SUNDRY NOTICES	AND REPORTS	ON WELLS
- Company	Do not use this form for	proposale to drill	ar ta ra anta

8. Well Name and No.
BIG EDDY UNIT #218

BEPCO, L.P. respectfully requests the changes listed below be approved for the captioned well:

### Big Eddy Unit 218 BEPCO, L.P. August 26, 2008 Conditions of Approval

DIAGRAM 2

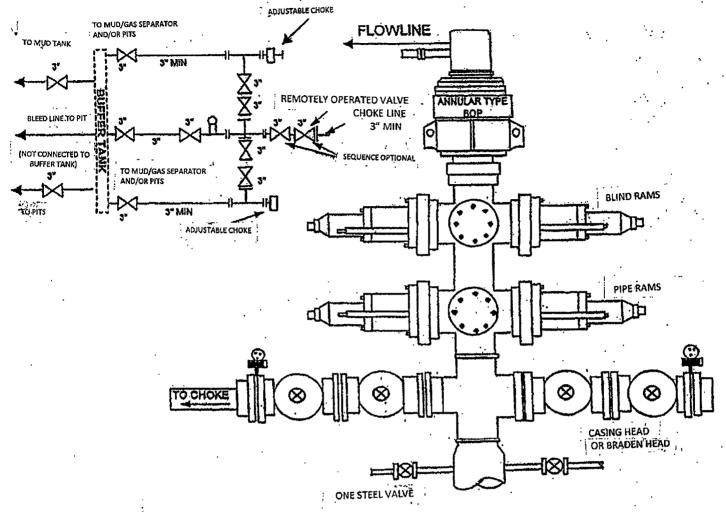
- 1) The well will be drilled utilizing a closed loop mud circulating system without a reserve pit being built or utilized. All water or mud used as drilling fluids will be cleaned and recycled or trucked to an approved disposal site. All drill cuttings will be collected and trucked to an approved disposal site.
- 2) A BOP equivalent to Diagram 2 will be nippled up on the surface casing head and tested to 1000 psig with the rig pump. A BOP equivalent to Diagram 1 will be nippled up on the intermediate casing and tested per the APD.

1. Based on the MASP that could occur prior to setting the intermediate casing (approximately 1600 psi using the heaviest mud for the surface hole) the BOP test is to be 2000 psi and a pressure test at that pressure must be done with a third party.
